Field of Dreams plan of Operations 2019

3809 LLCOF02000
COC-073930

PLAN OF OPERATIONS MODIFICATION INCOMPLETE AND ADDITIONAL INFORMATION REQUIRED

Gold Tamers LLC submitted a Plan of Operations Modification (MD-1) for the active Field of Dreams Mine located in T 09 S., R 77 W., Sec. 33, Park County, CO that was received by this office on April 02, 2019. In general, the modification proposes to expand the mining footprint and depth, as well as adding various types of equipment to the mining operation.

Figure 2.

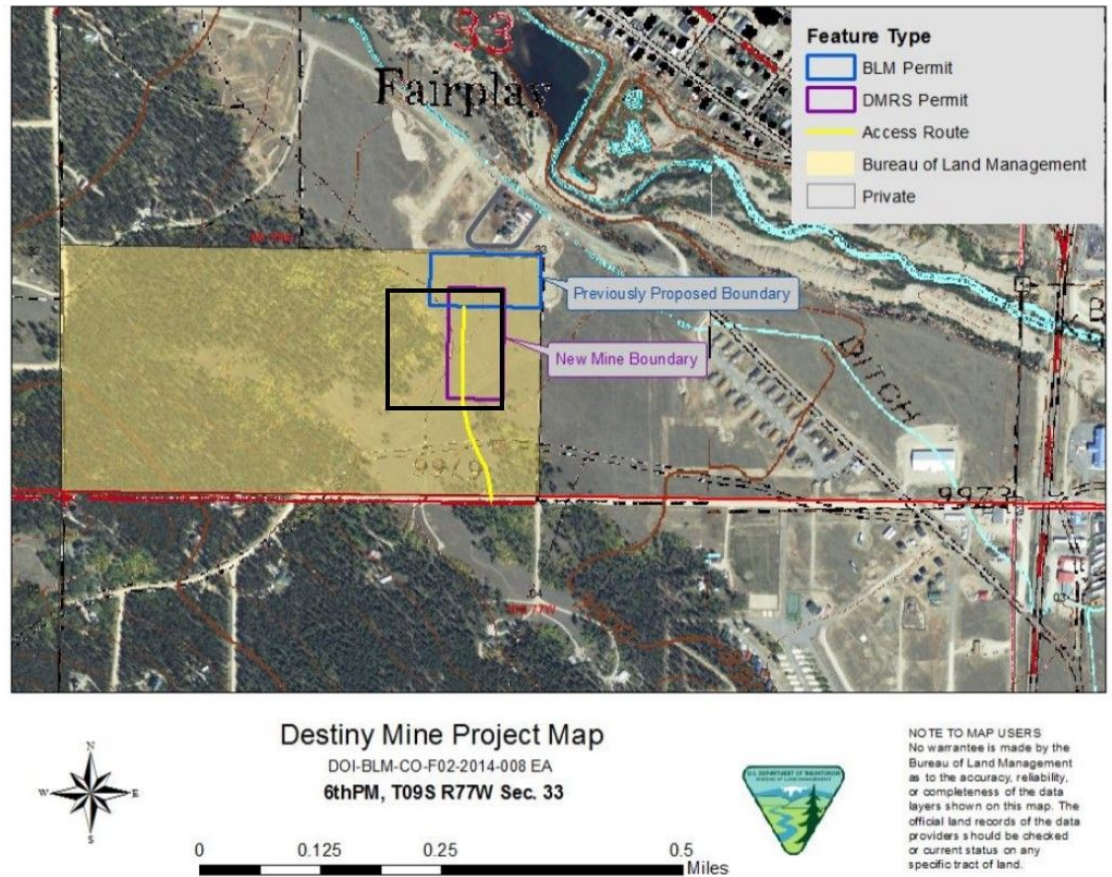
1. Clarify what aspects of the current Plan of Operations will continue to be implemented, as they relate to MD-1.
2. Provide a map of the modification area, as it relates to the existing authorized mine footprint. This map should be prepared at an appropriate scale showing, at a minimum, the location of the existing mine footprint, active mining area, processing facilities, waste rock and tailing storage areas, support facilities, structures, access routes, equipment staging areas, fuel storage area, traffic flow direction and location of the fence line.

- a. With the increased depth, and given that the surficial material consists of unconsolidated glacial till, please provide an adequate plan and cross-sectional design for the modified pit. Based on the design and standard engineering practices, provide the features and controls that will be needed to maintain structural integrity of the side slopes in an unconsolidated soil type. (Refer to AEG Consultants site investigation and corresponding write-up for existing authorized mine footprint, dated 06/27/2009.)
